# St Anthony of Padua Catholic School Redevelopment Modification 2

State Significant Development Modification Assessment  
(SSD-8865-MOD-2)

December 2022

**Figure 6 |** Proposed sign (Source: Applicant’s SRtS 2022)

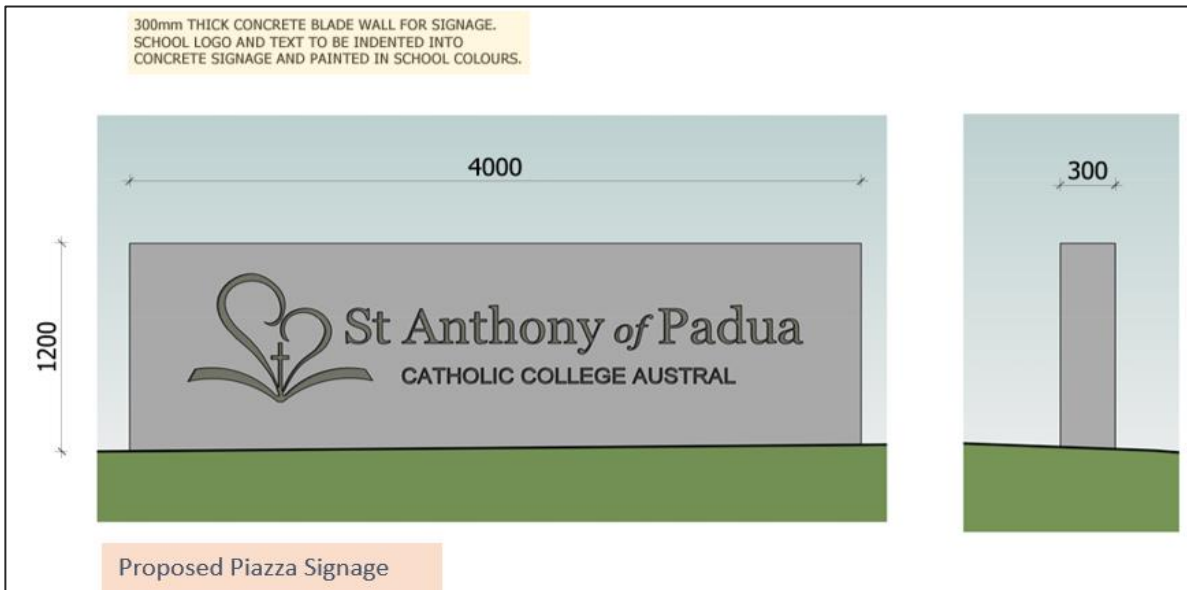
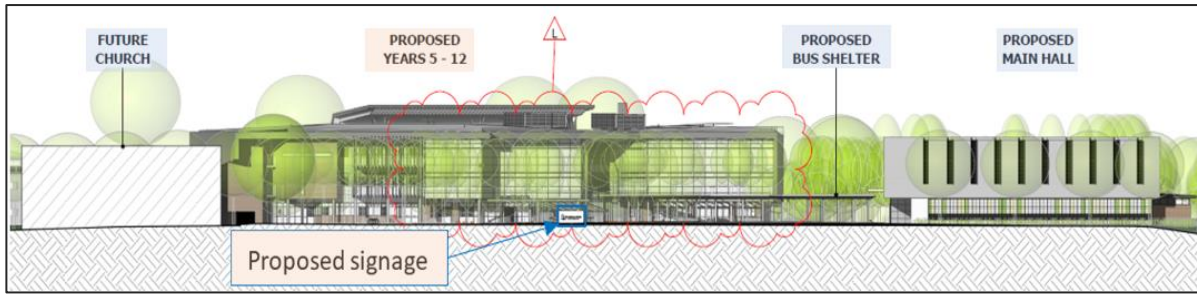
Council supported the proposed signage but commented that the new signage must ensure passive surveillance opportunities between the school, streetscape and the Piazza.

In response, the Applicant amended the size of the signage in the RtS and proposed a sign of size 1.2m x 4m with a 300mm thick blade wall.

The Applicant's RtS stated that the size of the sign has been reduced to improve passive surveillance and adhere to Crime Prevention Through Environmental Design principles.

**Figure 13** | Tree 496, proposed and revised sediment and erosion plan (Base source: Applicant's Modification Report and SRtS 2022)

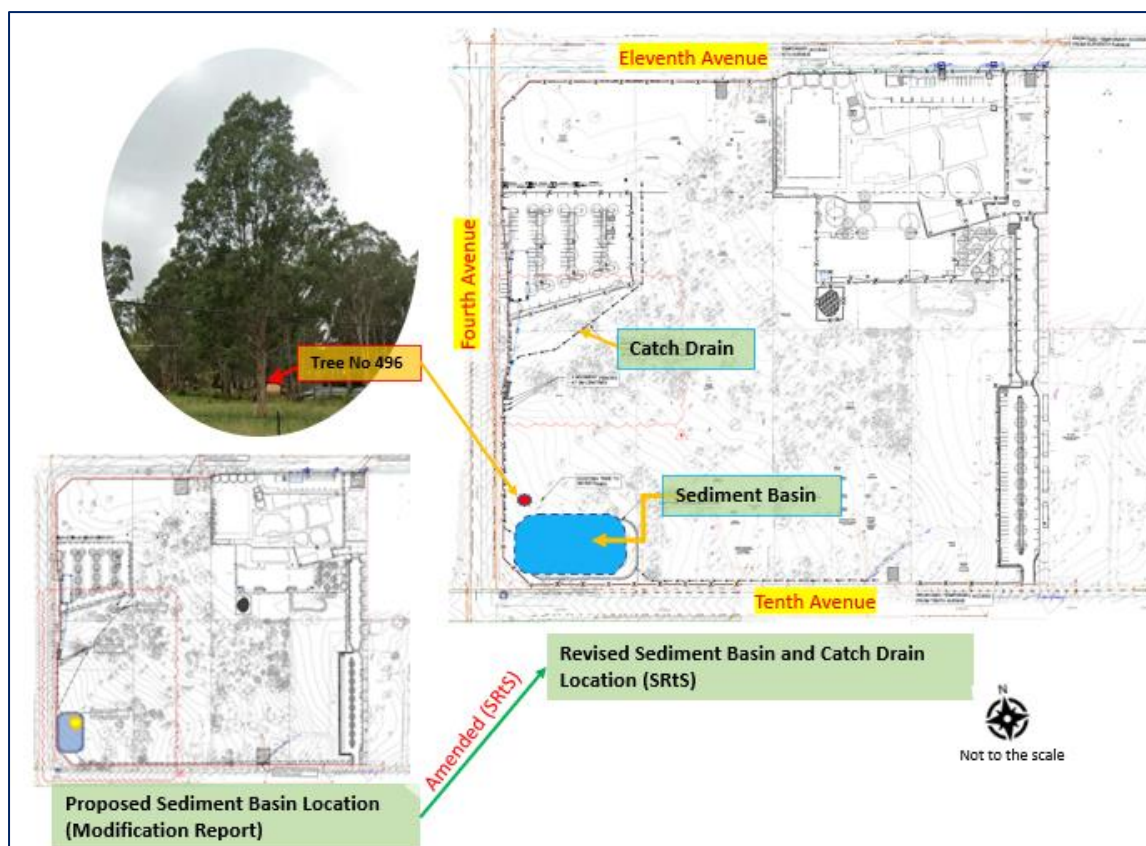
EHG advised that the proposed location of the sediment basin would impact Tree 496, a healthy and mature Forest red gum (*Eucalyptus tereticornis*) within the CPW. EHG requested the Applicant provide an updated Arboricultural Impact Assessment and recommended conditions to protect Tree 496, including:

- relocation of the sediment basin the south-western corner of the site away from the tree protection zone of Tree 496 and outside of the CPW area (Error! Reference source not found.).
- amendment to plans to reduce cut and fill impacts on Tree 496.

EHG also advised that that the Applicant's RtS did not include any amended civil plans to reflect the proposed changes to the sedimentation basin.

Following review of the SRtS, EHG raised further concerns regarding the adverse impacts of the location of the catch drains on the tree protection zones of the remnant trees within the CPW patch.

In response to the above comments, the Applicant submitted amended civil plans with the SRtS which comprised relocation of the sediment basin and the catch drain avoiding the tree protection zone of Tree 496 and the significant remnant trees within the CPW patch. The civil plans also demonstrated reduction in cut and fill within the CPW (Error! Reference source not found.).

EHG reviewed the amended plans and are satisfied that the proposed civil works would have no significant impact on the CPW.

- minor corrections to architectural drawings.
- revised civil plans, including relocation of the sediment basin to avoid Tree 496.
- proposed amended conditions and drawing list.
- further clarifications on the construction timing for carpark 2 and availability of carparking and drop-off/pick-up facility in Stage 1.

On 6 December 2022, the Applicant provided a further SRtS and amended drawings addressing the above comments.

EHG reviewed the amended plans and raised no further concerns regarding the proposed modification.

**Figure 14** | Proposed retaining wall adjoining the carpark (Base source: Applicant’s SRtS 2022)

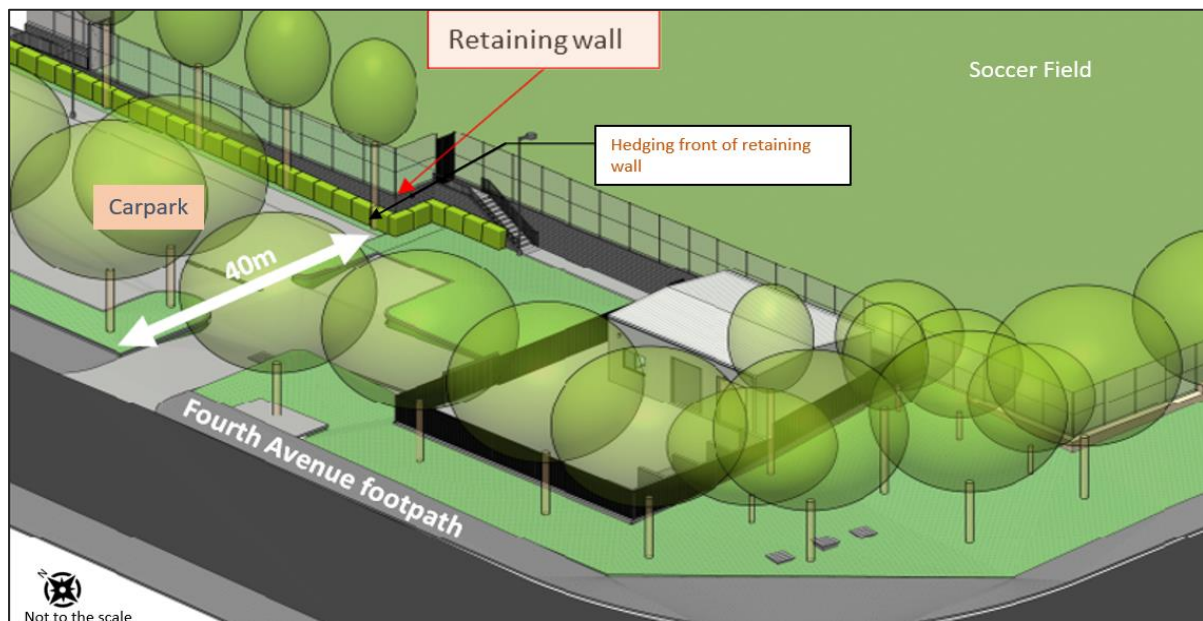
The Department notes that the concrete retaining wall ranges in height from 0.19m to 2.74m due to the slope of the site, with the highest point at the southern end. The retaining wall could cause some adverse visual impact when viewed from Fourth Avenue as it does not include articulation and is a continuous blank wall. However, the retaining wall is to be set back 40m from Fourth Avenue, located behind the approved carpark and is to be partially screened by proposed trees and shrubs.

Based on the above, the Department considers that the visual impact of the retaining wall from Fourth Avenue has been reasonably minimised to not significantly impact on the streetscape. The additional tree planting would enhance visual screening of the soccer field, differentiate it from the carpark and provide an appropriate transition to the public domain (**Figure 14**).

**Figure 17** | Proposed materials schedule (Base source: Applicant's SRtS 2022)

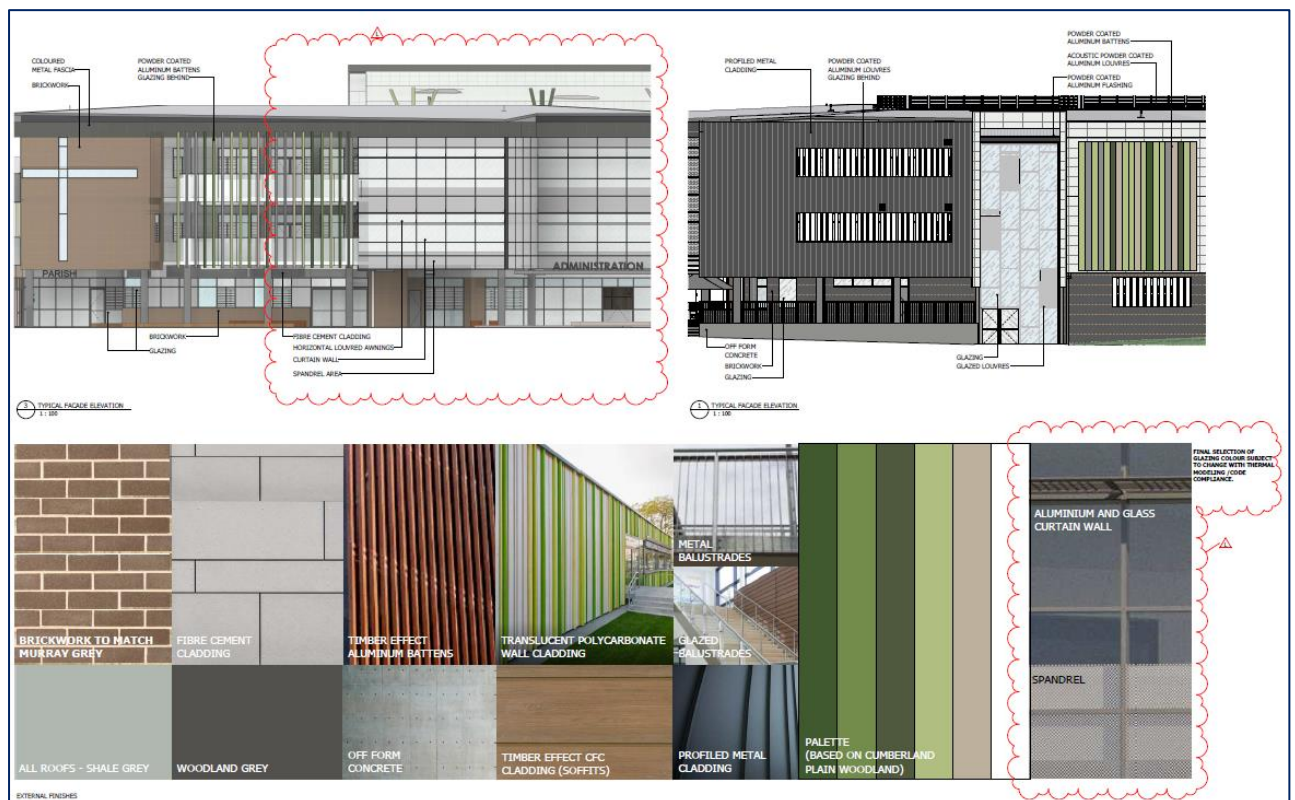
Council reviewed the amended external materials and stated that it should improve passive surveillance onto the school open space.

The RtS argued that the glass curtain wall improves passive surveillance allowing views from Eleventh Avenue to the school building (**Figure 16** and **Figure 17**).

Council has not raised further concerns in this regard. The Department has considered the information provided and is satisfied that modification to the external materials is compatible with the
